ADDENDUM

ADDENDUM #: 1 GRP PROJECT #: **17017_B**

DATE: March 9, 2018

PROJECT: Town Common Restroom (Site Work)

ADDENDUM 1:
LIMIT OF CONCRETE DEMOLITION AND INSTALLATION BY OTHERS

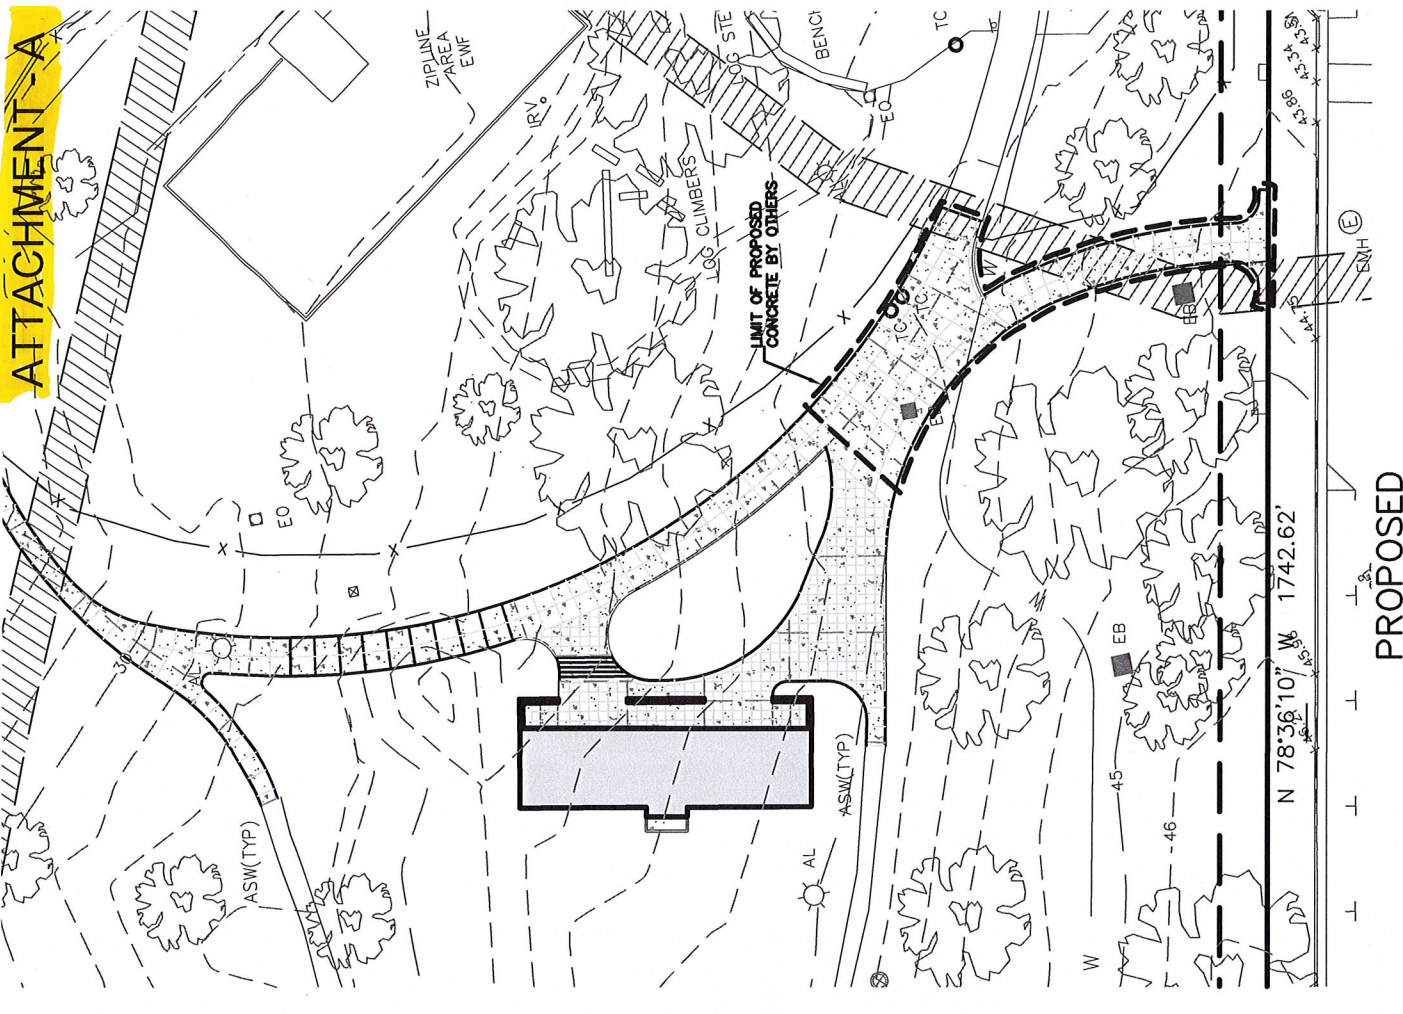
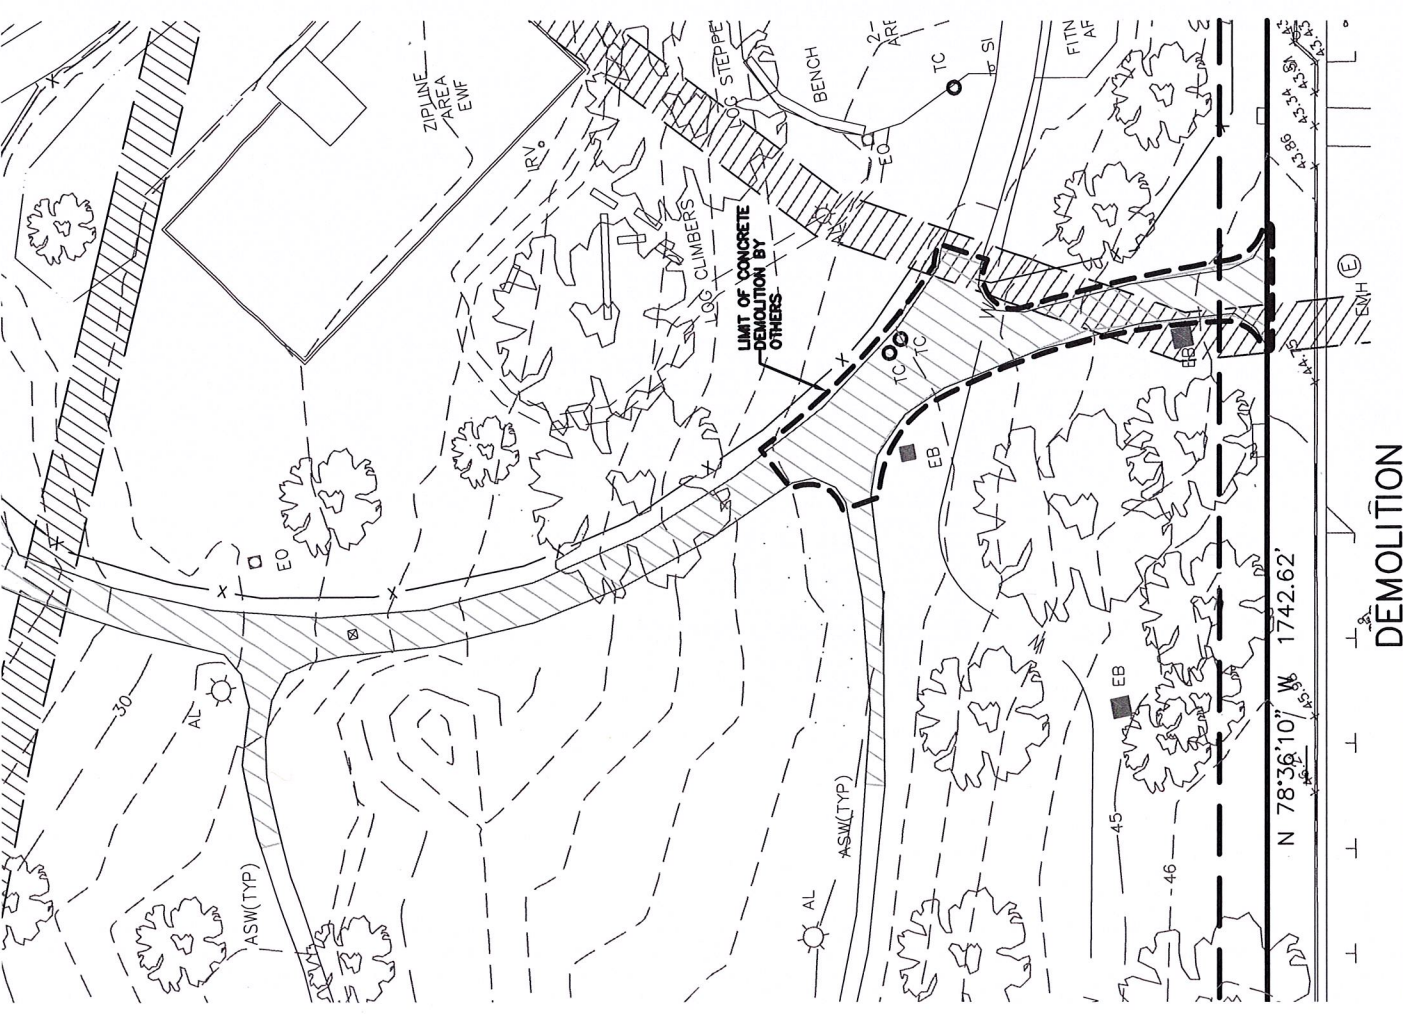
- 2). Sheets L0.2 and L2.1; approximately 1,500 sq. ft. of concrete pavement shall be installed by others. Refer to the drawing on Attachment-A drawing for the limits of concrete demolition and installation by others.
- 3). Sheets L1.1 and L6.1; OMIT all references to four (4) backless benches. OMIT detail 4/L6.1. All site furnishings, including benches shall be installed by others.
- 4). Sheet L4.1 and L4.2; OMIT all references to planting and sod. All planting shall be by others.
- 5). Sheet L6.1; On detail 6/L6.1 and 8/L6.1 REPLACE all references to stainless steel with galvanized steel.
